# Equipment Technical Bulletin

## Motor Gearbox Replacement

*Motor Gearbox with Torn Label*

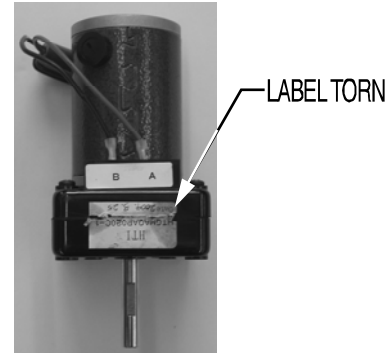
Vendor left a spacer out of some gearboxes assemblies in a small lot of the assemblies. These need to be replaced with new motor gearboxes or excessive wear and premature failure could result.

The absence of the spacer has resulted in torn labels as shown in the pictures.

1. Install new motors sent with this technical bulletin.
2. Discard old motors.
